Remarks

Reconsideration of this Application is respectfully requested.

FIG.2A

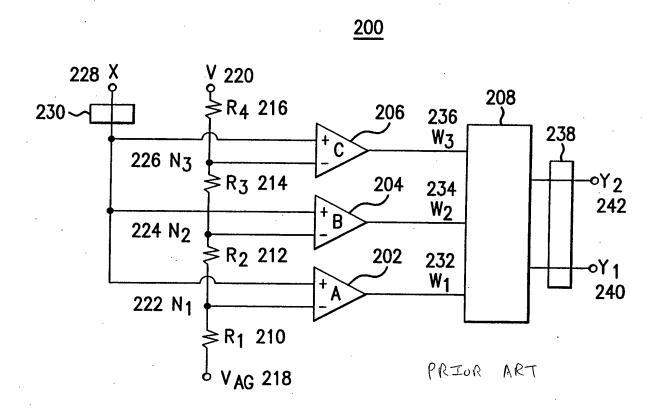
The Office Action objected to Figures 2A, 2B, and 3 because they lack a legend indicating that they illustrate prior art. (See, Office Action at ¶ 2.) Accordingly, Applicants have amended, in a Request to Approve Proposed Drawing Corrections filed herewith, Figures 2A, 2B, and 3 as recommended by the Examiner to include the legend "Prior Art".
